VIRGINIA ELECTRIC AND POWER COMPANY
RICHMOND, VIRGINIA 23261

VIRGINIA ELECTRIC AND POWER COMPANY
NORTH ANNA POWER STATION UNITS 1 AND 2
PROPOSED TECHNICAL SPECIFICATION CHANGES
REVISED CONTAINMENT ANALYSIS

Attachment 1
Discussion of Changes

Mark-up of Unit 1 and Unit 2 Technical Specifications Changes

Figure 3.6-1: Containment Air Partial Pressure versus Service Water Temperature

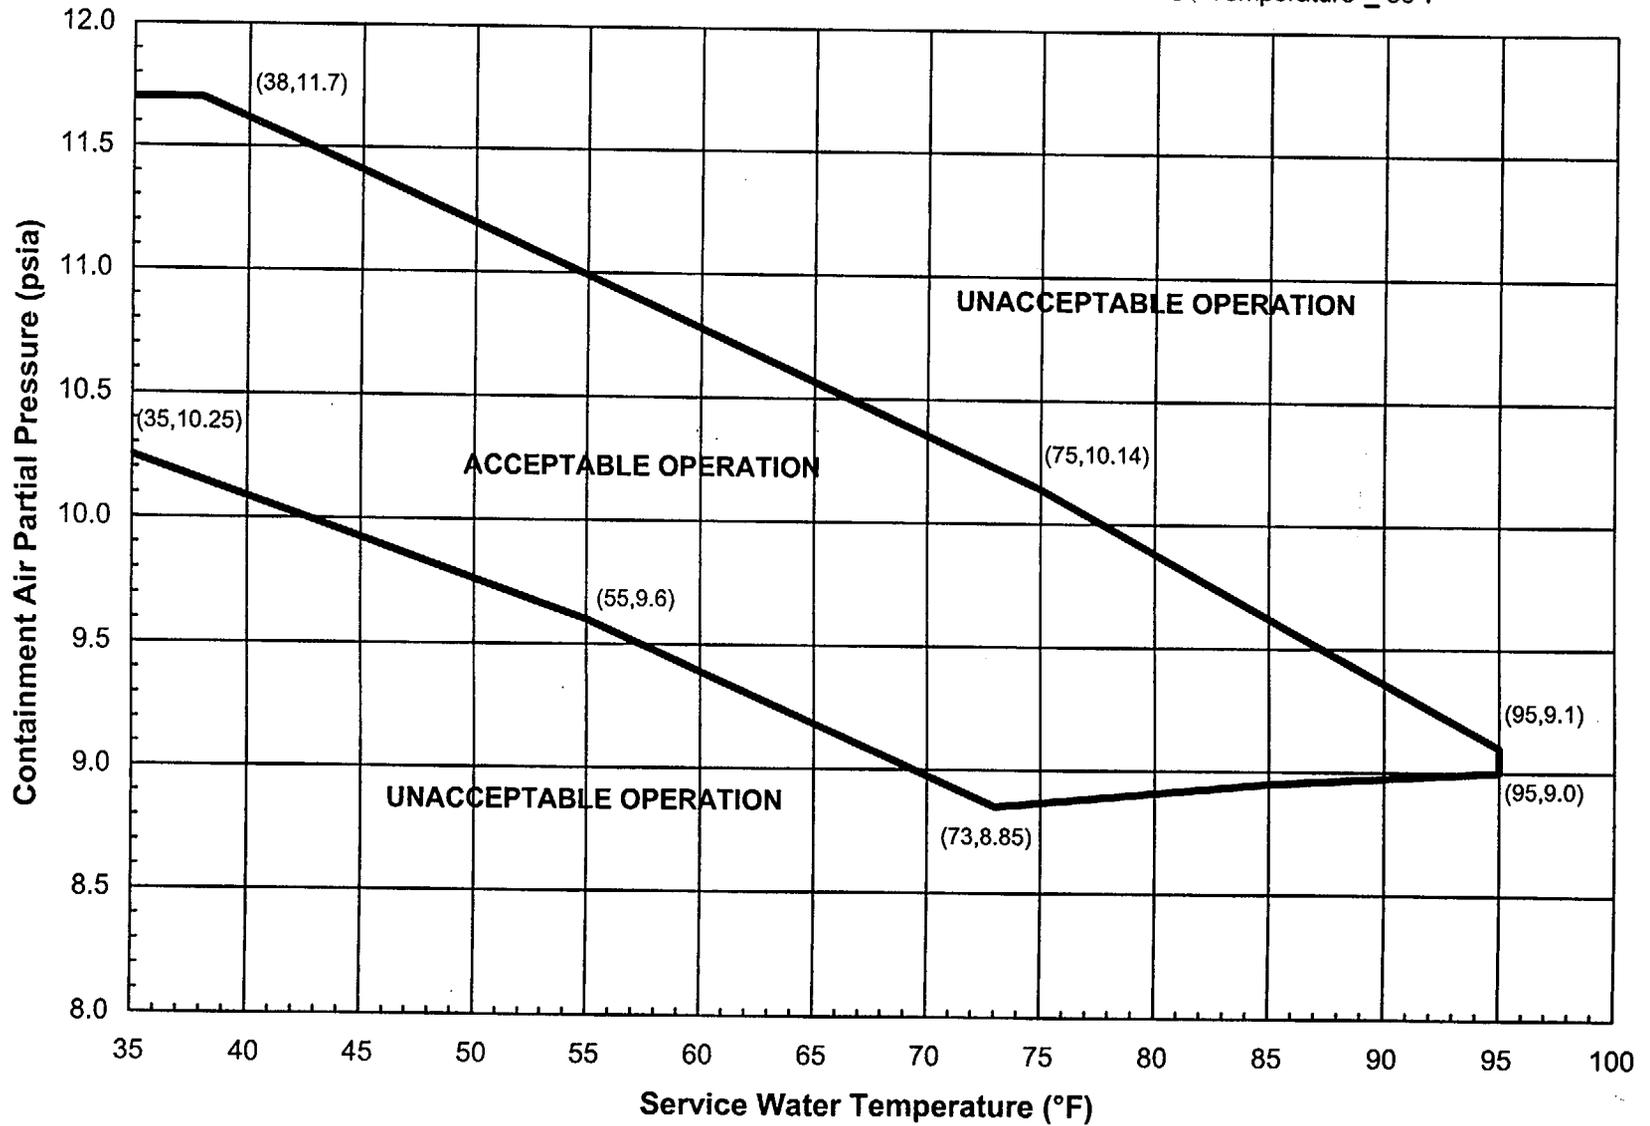
With the containment internal air partial pressure outside the acceptable operation region shown on Figure 3.6-1, restore the internal air partial pressure to within the limits within 1 hour or be in at least HOT STANDBY within the next 6 hours and in COLD SHUTDOWN within the following 30 hours.

Ranges:
Containment Temperature 86-120°F
RWST Temperature $\leq 50^\circ\text{F}$

Figure 3.6-1: Containment Air Partial Pressure versus Service Water Temperature

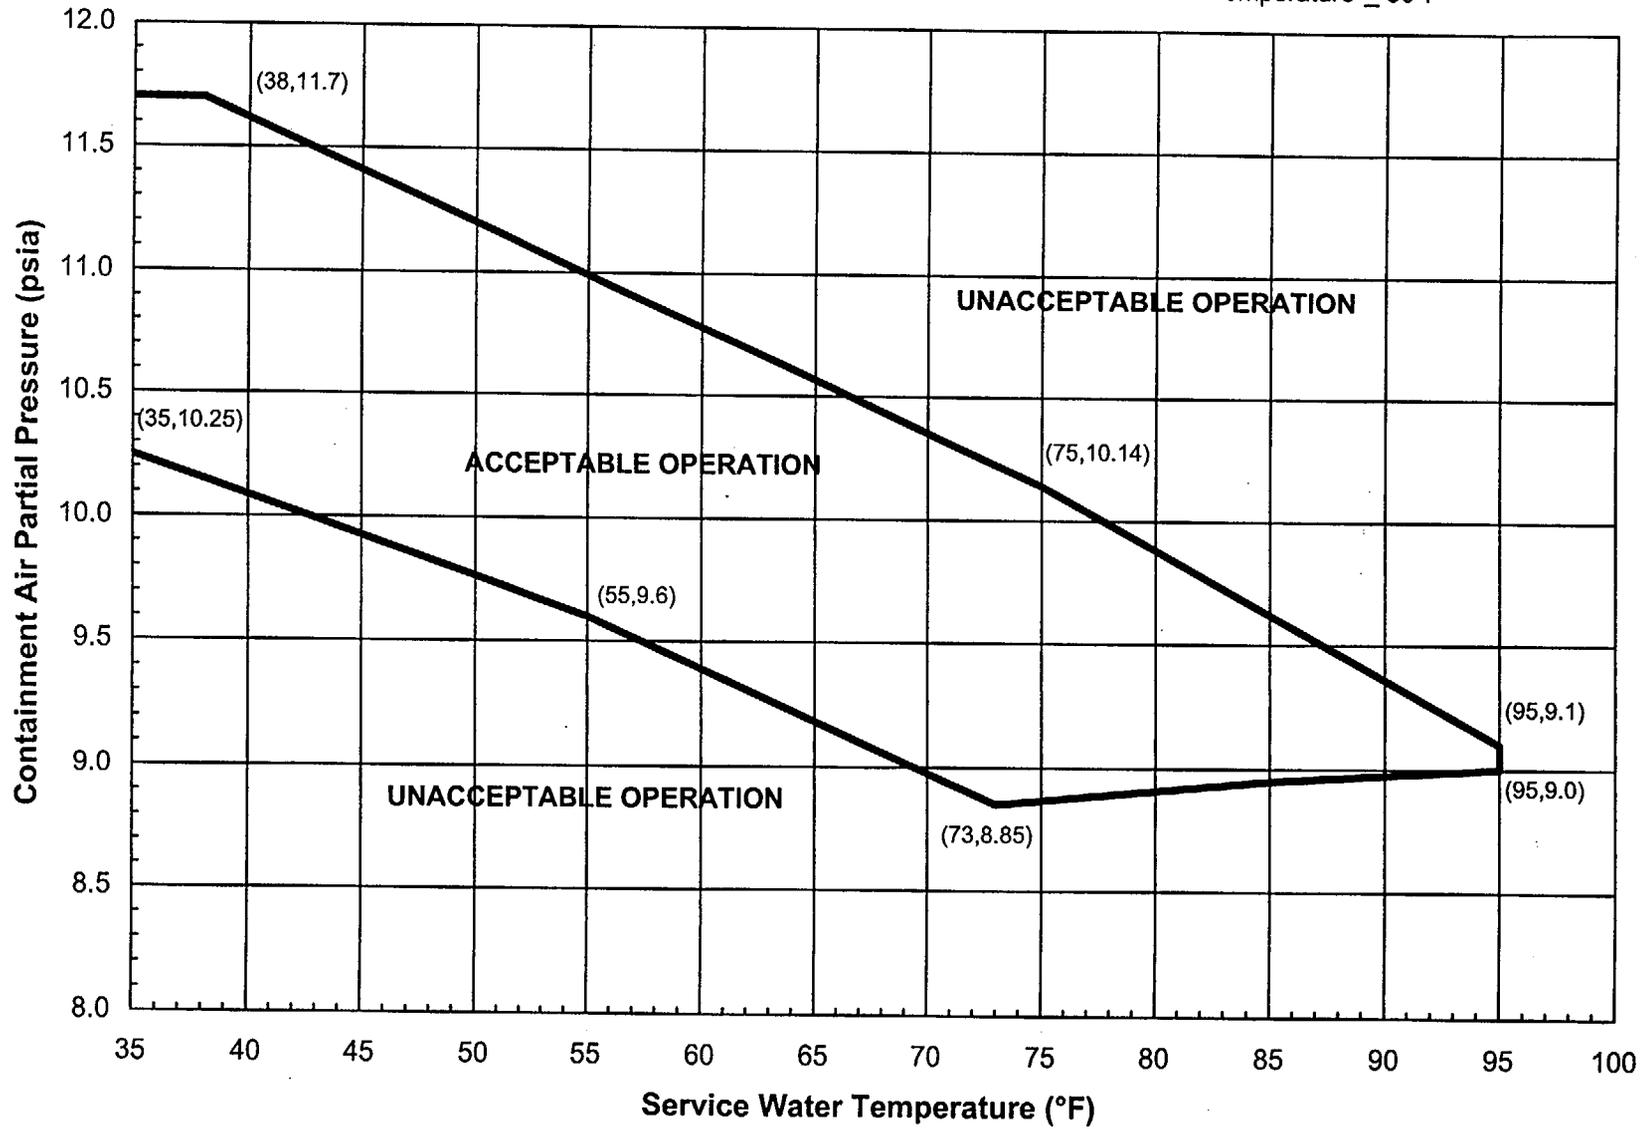
With the containment internal air partial pressure outside the acceptable operation region shown on Figure 3.6-1, restore the internal air partial pressure to within the limits within 1 hour or be in at least HOT STANDBY within the next 6 hours and in COLD SHUTDOWN within the following 30 hours.

Ranges:
Containment Temperature 86-120°F
RWST Temperature $\leq 50^\circ\text{F}$

Figure 3.6.4-1 (page 1 of 1)
Containment Air Partial Pressure Versus
Service Water Temperature

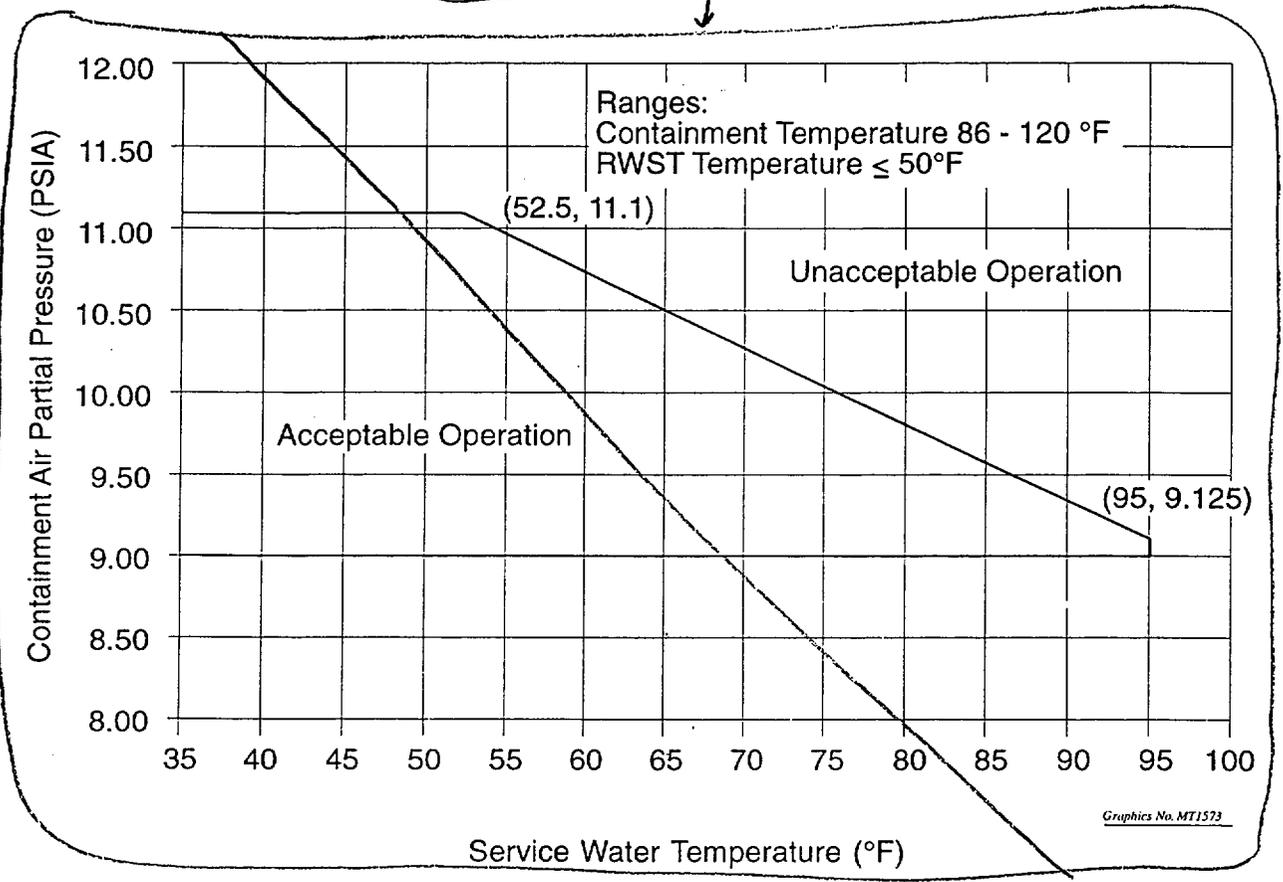
LCO 3.6.4 Containment air partial pressure shall be ≥ 9.0 psia and within the acceptable operation range shown on Figure 3.6.4-1.

Replace with
new Figure
3.6.4-1

Figure 3.6.4-1 (page 1 of 1)
Containment Air Partial Pressure Versus
Service Water Temperature

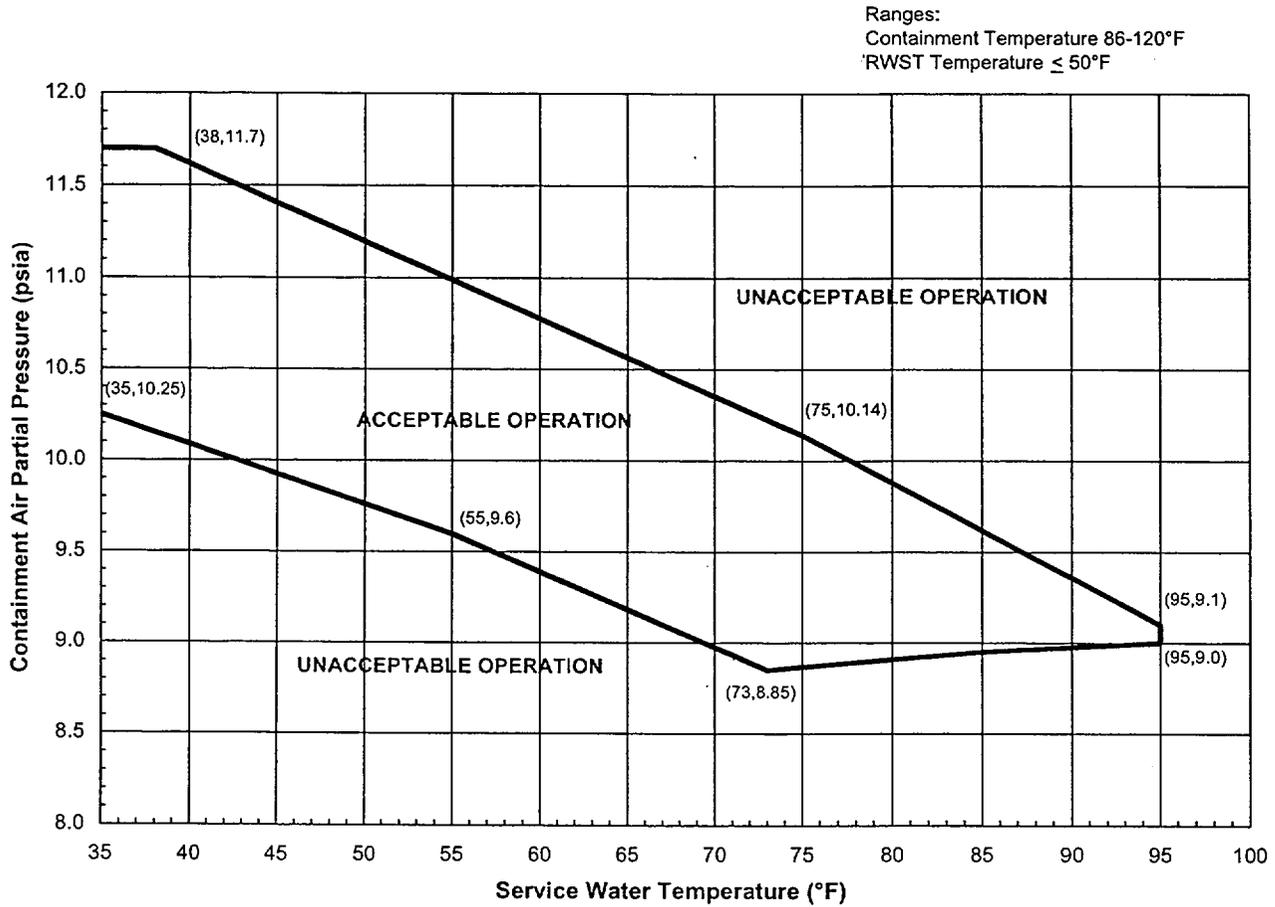
LCO 3.6.4 Containment air partial pressure shall be within the acceptable operation range shown on Figure 3.6.4-1.
